TDK Corporation

Process Change Notice

Non cyanide stabilizer compound solution for Au plating process.

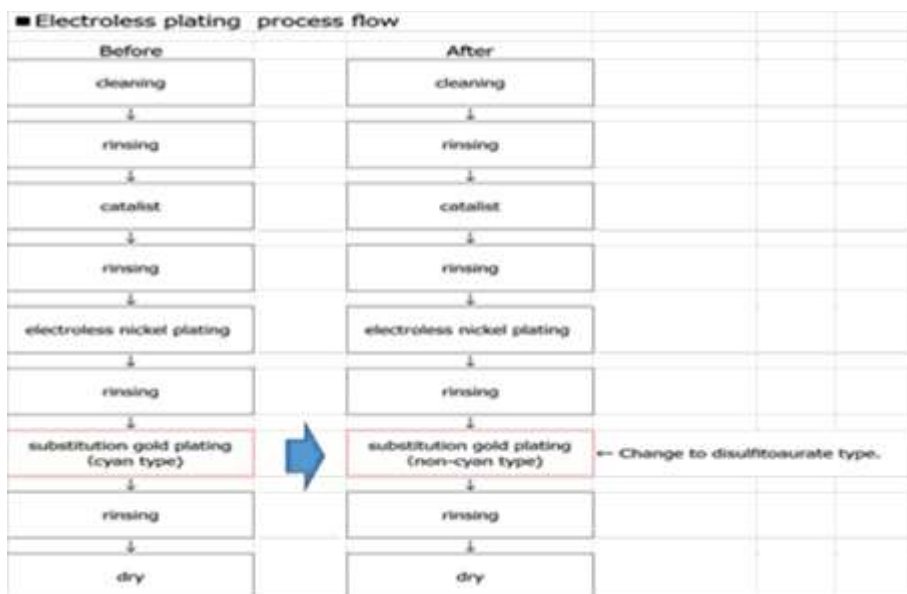
. Thank you very much for your support. We are currently using a material cyanide compounds, which is a poison, as a stabilizer for the gold plating bath in the plating process for terminal electrodes. , however we will change non cyanide compound for gold terminal plating solution.

To reduce environmental risk and no limitation of factory equipment and location., There is no change that the plating material formed in the process is gold and it does not affect the quality.
